# UNITED STATES PATENT AND TRADEMARK OFFICE

10/524,273

<b>Office Action Summary</b>	Application No. 10/524,273	Applicant(s) MARTI SENDRA ET AL.	
	Examiner Omar Rojas	Art Unit 2874

## **DETAILED ACTION**

*In re* claim 1, Kosaka discloses a system of coupling between a dielectric optical guide 13 and a planar photonic crystal guide 12, characterised by the fact that it consists of a coupling structure 11 necessary for adapting the width between both guides. Figure 2 of Kosaka is reproduced below.

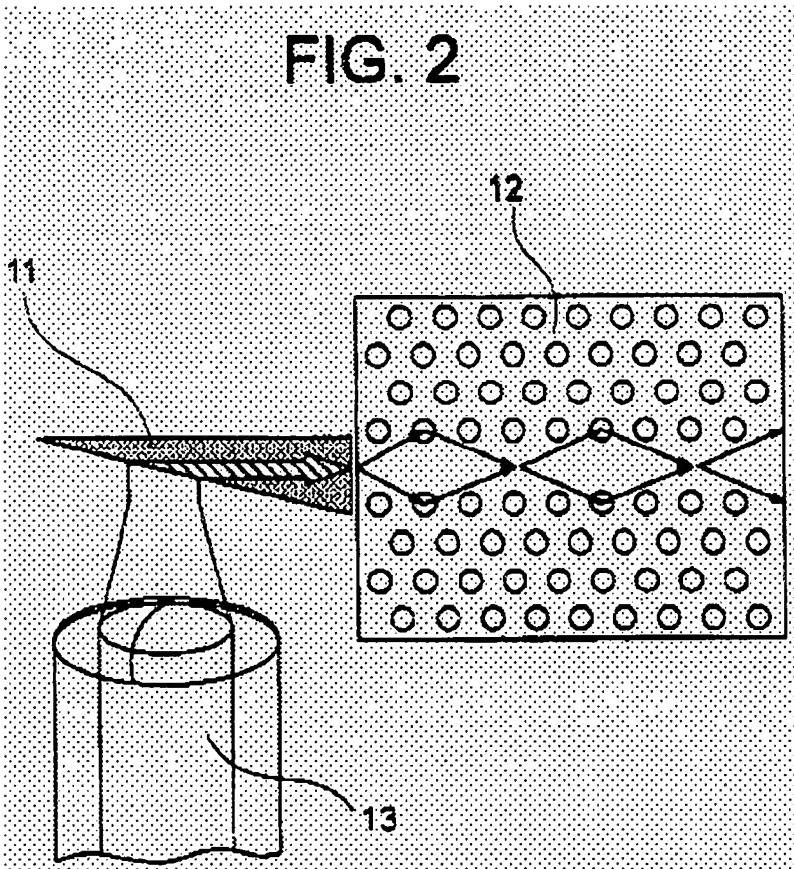
*In re* claim 2, the coupling structure 11 of Kosaka inherently has a length, width and shape, as seen in Figure 2, depending on the characteristics of both the dielectric guide 13 and the photonic crystal guide 12.

*In re* claim 3, the photonic crystal guide 12 of Kosaka inherently has a grid constant, radius and height of the cylinders and contrast of indices between the material of the columns, the material surrounding the columns and the material above and below the crystal as suggested by Figure 2.

Figure 17(a) of Dridi is reproduced below.

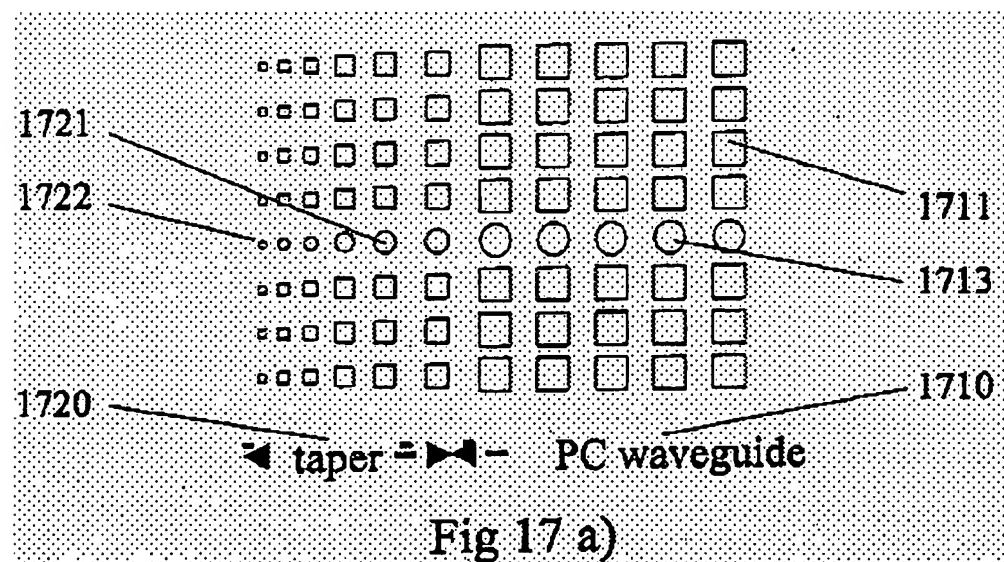
Dridi, on the hand, discloses introducing point defects 1721,1722 into a coupling structure (Figure 17) by selecting a particular number of defects and one or more defect characteristics including radius, dielectric constant, relative position and height. *See* Dridi at paragraph [0146].

*In re* claim 6, an optimum number of defects 1721, 1722 is inherently chosen in Dridi as well as the characteristics of each one of them, both for introducing the light from a dielectric guide into a photonic crystal guide as for extracting the light from a photonic crystal guide into a dielectric guide because Dridi teaches low loss adiabatic transfer of energy between waveguides. *See* Dridi at paragraph [0047]. Therefore, it would have been obvious to one of ordinary skill in the art at the time of the claimed invention to obtain the invention specified by claim 6 in view of Kosaka combined with Dridi for the same reasons given with respect to claims 1-5.
